ENVIRONMENTAL IMPACT REPORT COMMENTS AND RESPONSES

San Francisco Museum of Modern Art Expansion / Fire Station Relocation and Housing Project

PLANNING DEPARTMENT
CASE NOS. 2009.0291E and 2010.0275E
STATE CLEARINGHOUSE NO. 2010102047
October 27, 2011

RE: Attached Comments and Responses on the Draft Environmental Impact Report for the SFMOMA Expansion and Fire Station Relocation and Housing Project (Planning Department Case Nos. 2009.029E and 2010.0275E)

FIGURE II-18
Revised

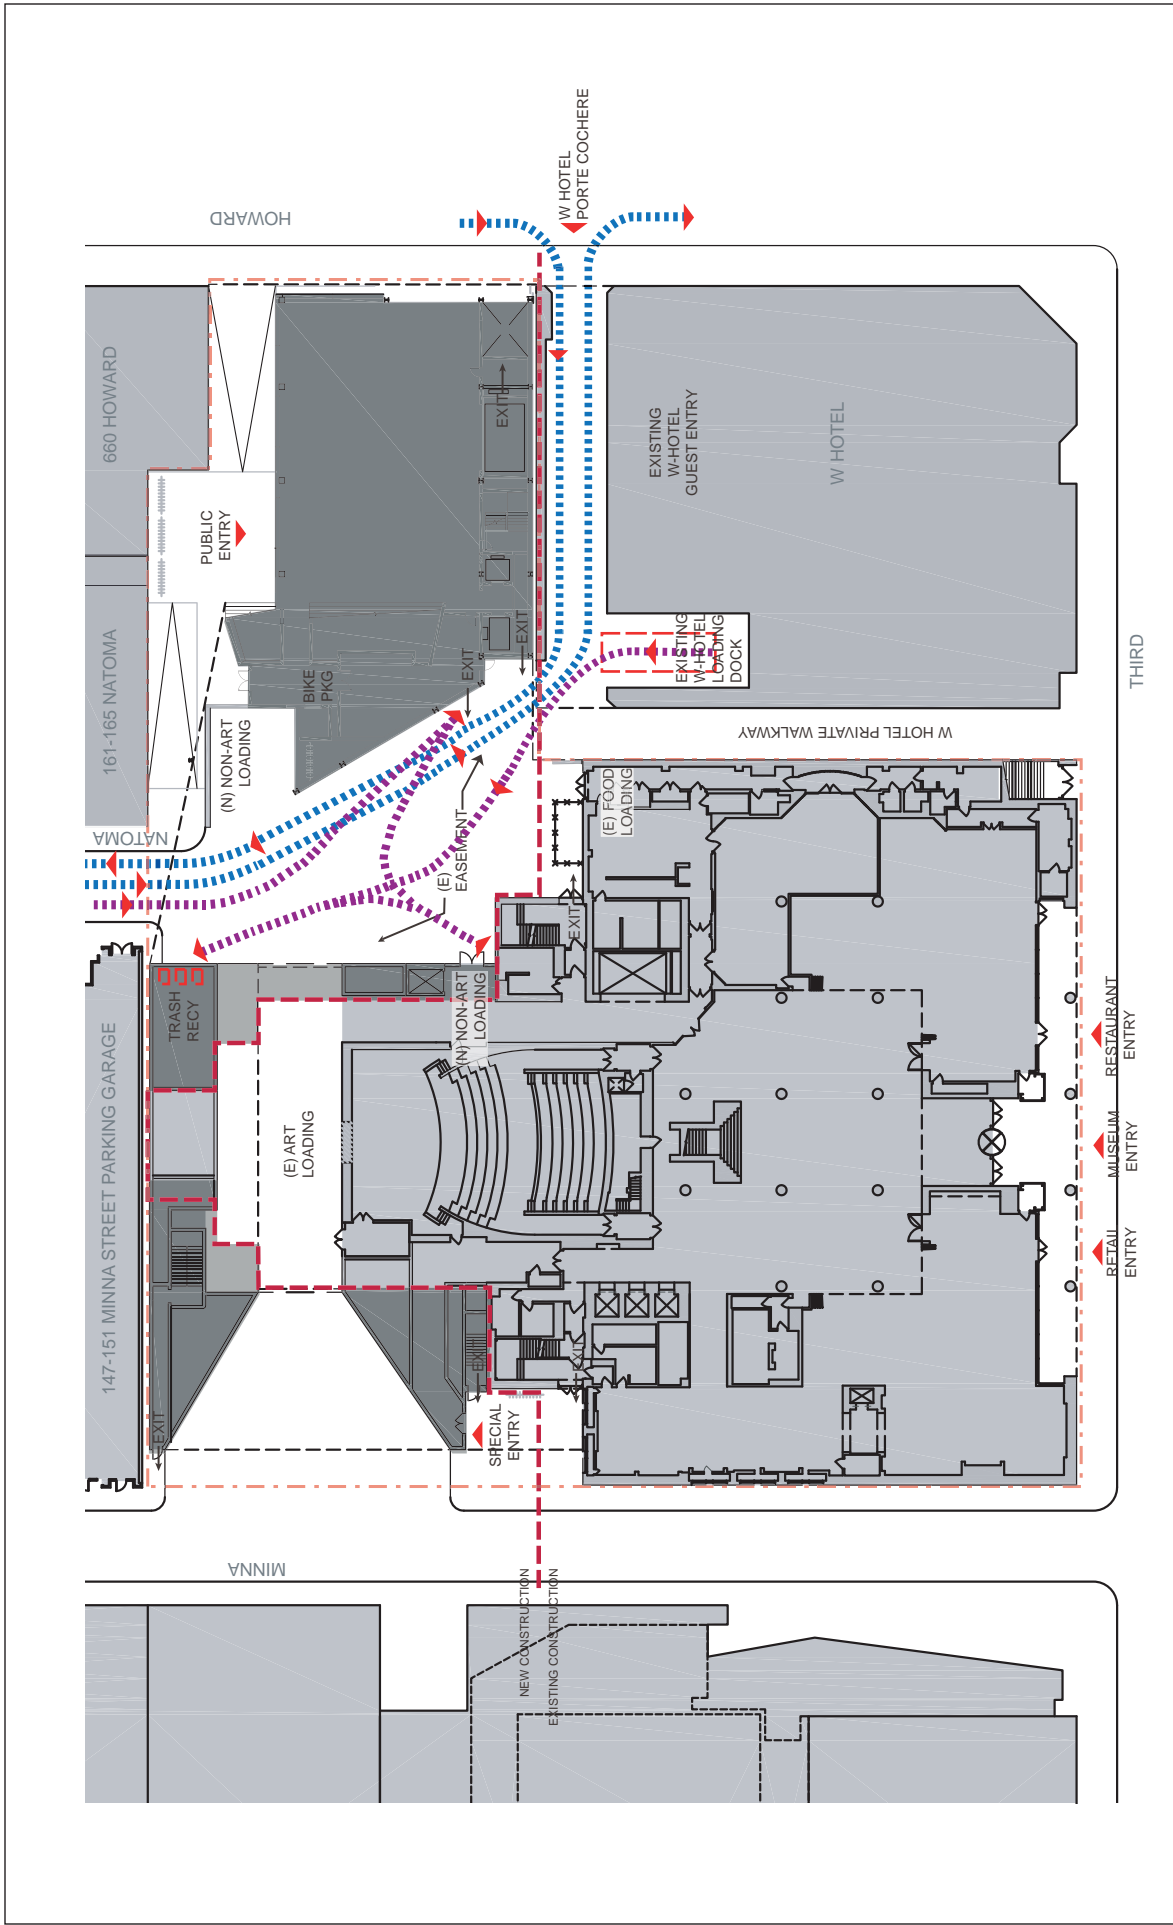
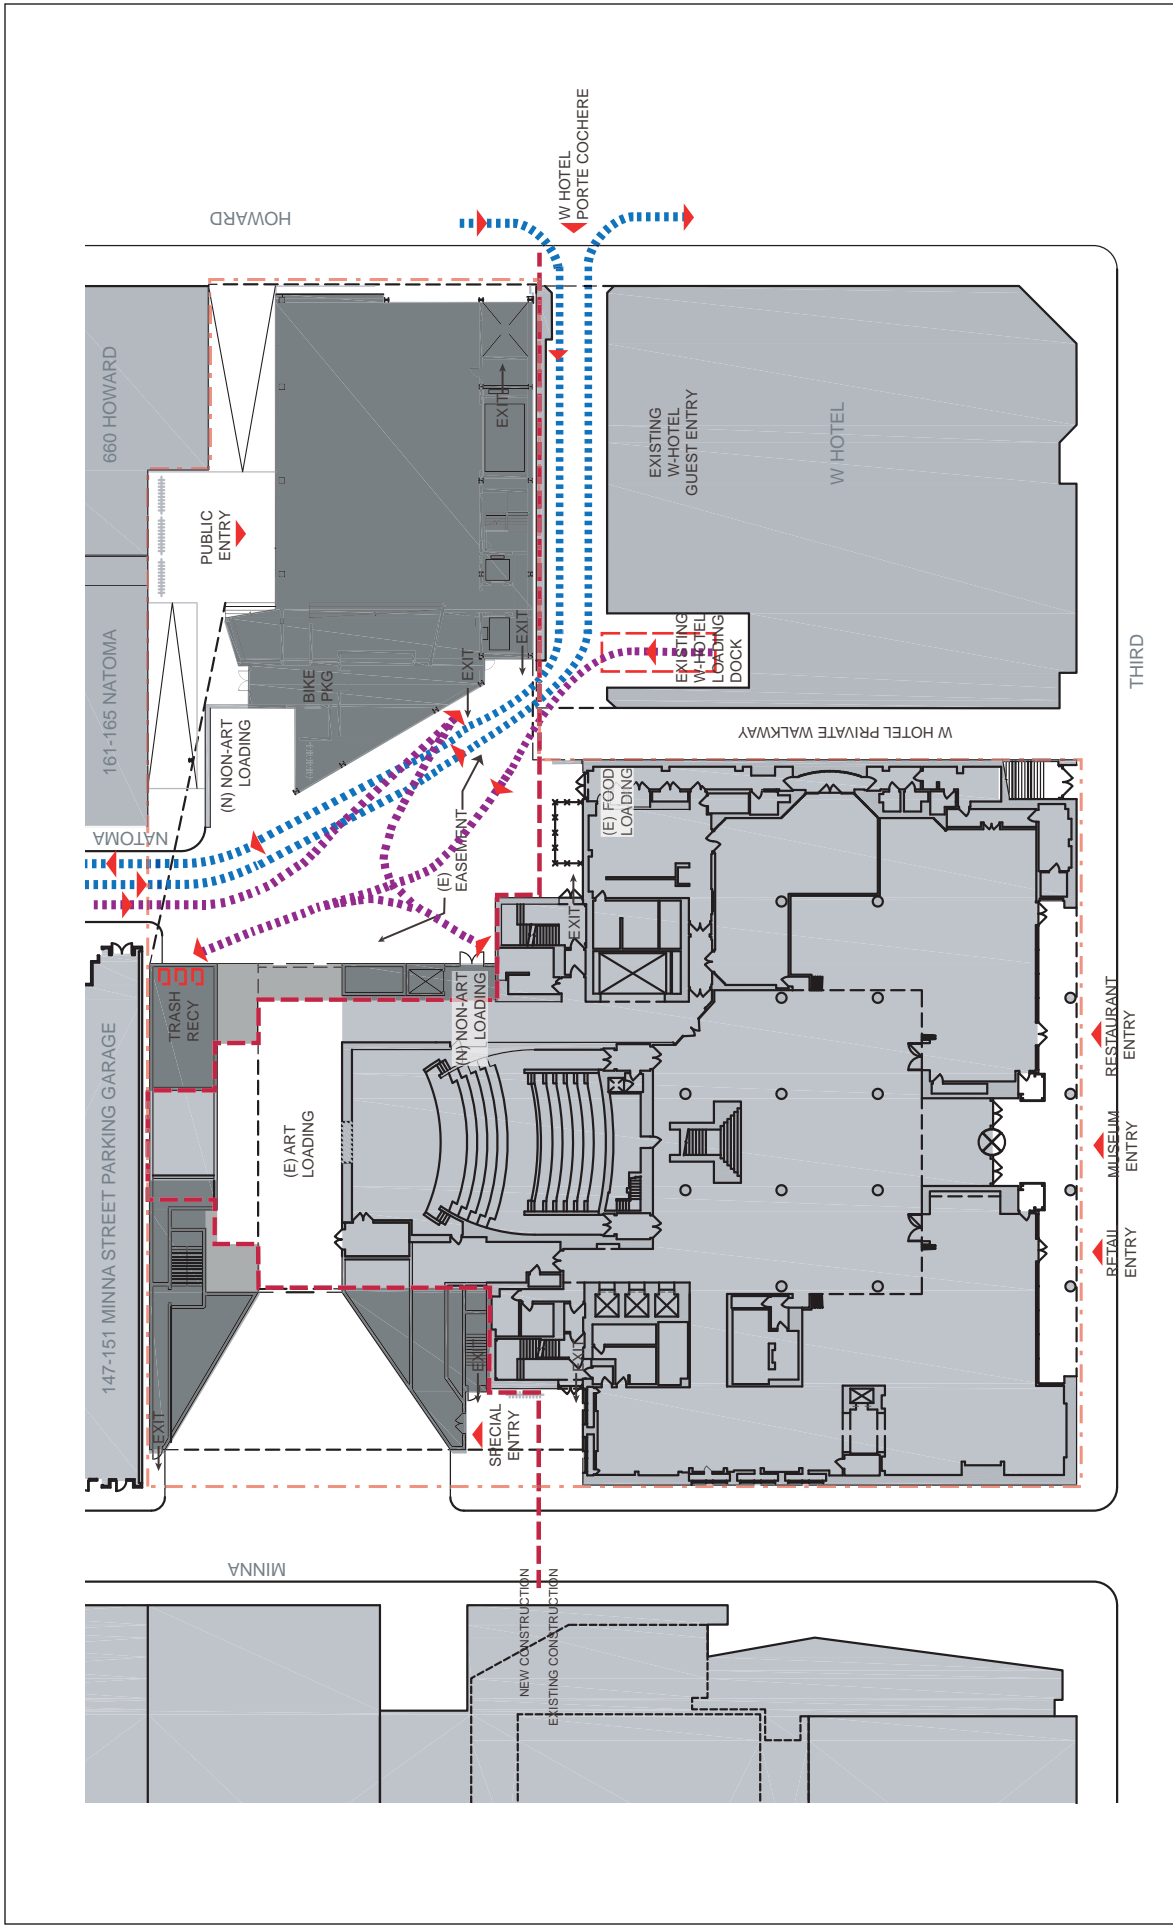
From its operational experience, the W takes specific issue with Figure II-18, which ostensibly diagrams loading movements for the W Hotel after construction. This diagram does not reflect feasible or operationally satisfactory accommodations for truck and vehicle movements. For example, the diagram indicates that both truck movements and vehicle movements could proceed through the porte-cochere at the same time (in fact, the diagram shows a truck parked in the porte-cochere and routes for both trucks and valet along side). This is physically impossible. We are attaching photo-

Figure II-18 in the DEIR also shows trucks completing a maneuver by which they swing into Howard Street and then back into the porte-cochere—a move that would block at least two, and likely all, lanes of traffic for several minutes (for each delivery) if it can be accomplished at all. See Exhibit C. Currently, the majority of the hotel's truck deliveries occur between 7 a.m. and 10 a.m., corresponding closely to the peak morning commute traffic. Given these conditions, if loading occurs as described in the DEIR, several lanes of traffic will be held at a standstill for significant portions of the weekday morning peak hours. This would undoubtedly lower nearby intersection operations from LOS E to LOS F, which is considered unacceptable in the DEIR (DEIR, p. 212.), and would certainly be unacceptable to drivers trying to make their way across the City.

From its operational experience, the W takes specific issue with Figure II-18, which ostensibly diagrams loading movements for the W Hotel after construction. This diagram does not reflect feasible or operationally satisfactory accommodations for truck and vehicle movements. For example, the diagram indicates that both truck movements and vehicle movements could proceed through the porte cochere at the same time (in fact, the diagram shows a truck parked in the porte cochere and routes for both trucks and valet along side). This is physically impossible. We are attaching photographs showing the room available in the porte cochere for vehicular movements with Exhibit C. A truck and a car cannot occupy the same space in the porte cochere at the same time.

Figure II-18 in the DEIR also shows trucks completing a maneuver by which they swing into Howard Street and then back into the porte cochere—a move that would block at least two, and likely all, lanes of traffic for several minutes (for each delivery) if it can be accomplished at all. See Exhibit C. Currently, the majority of the hotel's truck deliveries occur between 7 a.m. and 10 a.m., corresponding closely to the peak morning commute traffic. Given these conditions, if loading occurs as described in the DEIR, several lanes of traffic will be held at a standstill for significant portions of the weekday morning peak hours. This would undoubtedly lower nearby intersection operations from LOS E to LOS F, which is considered unacceptable in the DEIR (DEIR, p. 212.), and would certainly be unacceptable to drivers trying to make their way across the City.

Figures II-17 and II-18 in the Project Description are intended to be illustrative, and do not depict specific turning radii or travel lanes for existing and proposed conditions. Figure II-18 is intended to illustrate the various possible routes for access to the W Hotel loading dock and porte-cochere. Figure II-18 has been revised to reflect the proposed access to the loading dock only from Natoma Street. The revisions do not change the analysis or conclusions in the Draft EIR.

More detailed truck turning templates for existing and proposed project conditions are included in this Comments and Responses Document as Figures 2 through 6. These figures clarify the existing and proposed loading plans and do not change the analysis or conclusions in the Draft EIR.

Figure II-18 on page 29 of the Draft EIR is revised to show how two-way travel between Natoma Street and the W Hotel's porte-cochere will be accommodated to remove use of the porte-cochere for loading access. Truck turning templates have been added to show how trucks will be able to back into the W Hotel's loading dock.

FIGURE IV.E-4
Revised

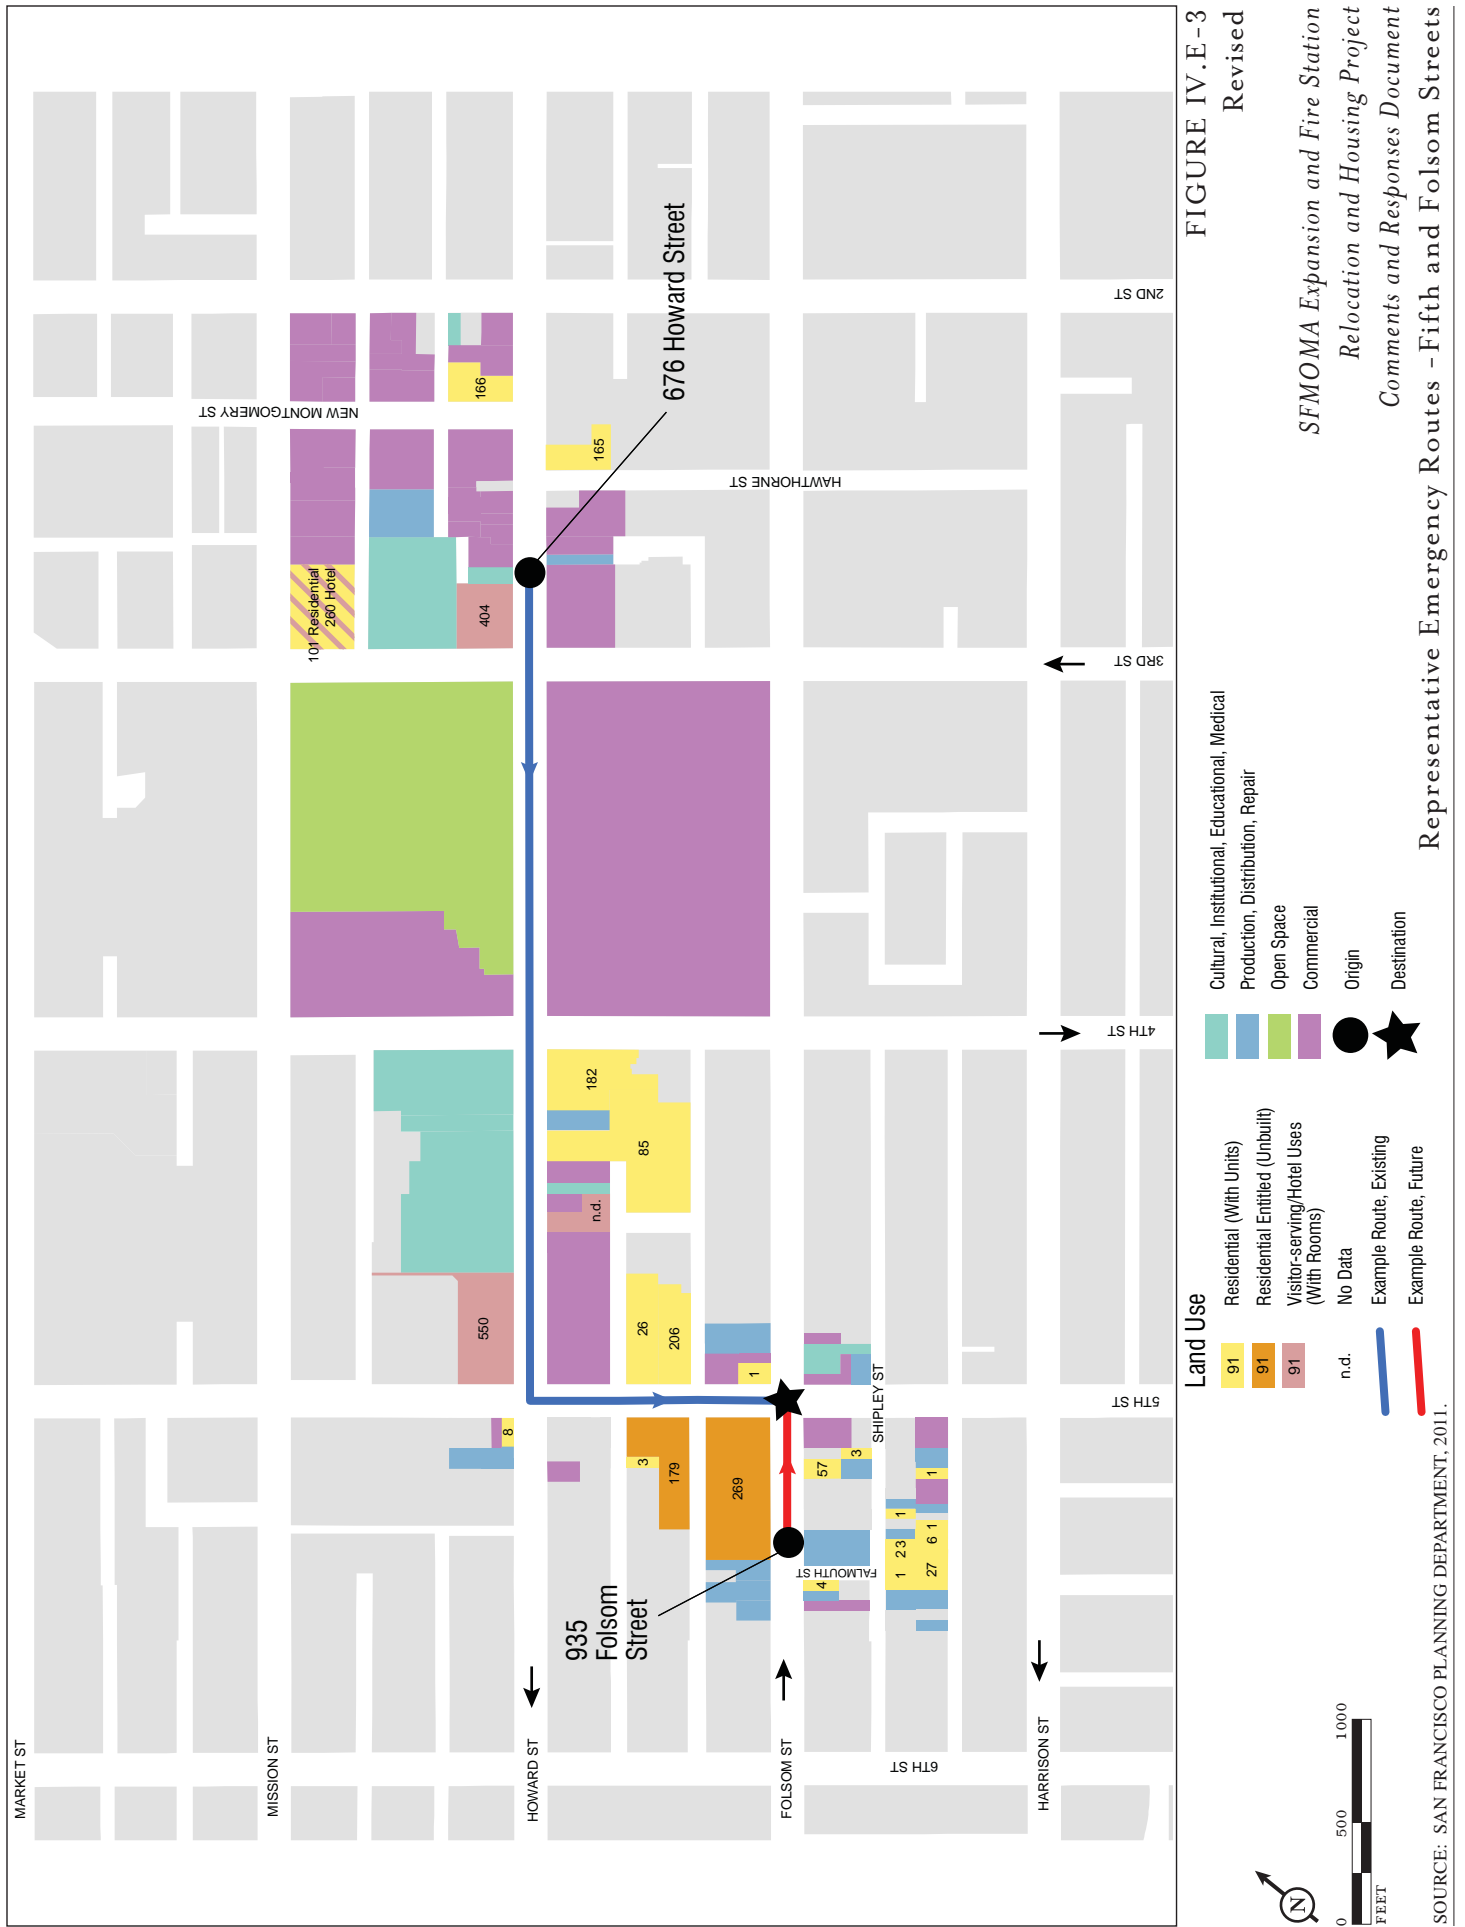
“If most of the response calls for Fire Station No. 1 are in the Tenderloin and the 6th Street corridor, fire trucks driving the wrong direction on the Folsom does not seem safe. See Figure IVE.4, pg 334.”
(Anne Marie Kuban, August 24, 2011, Letter)

1. The Fire Station's daily preparation / testing activities will cause adverse traffic conditions on Folsom in morning rush hour traffic.
2. Standing traffic on Folsom between Essex and 6th street, to gain freeway access is a typical occurrence, especially at evening rush hour, weekends and during AT&T events.
3. If most of the response calls for Fire Station No. 1 are in the Tenderloin and the 6th Street corridor, fire trucks driving the wrong direction on the Folsom does not seem safe. See Figure IVE.4, pg 334.
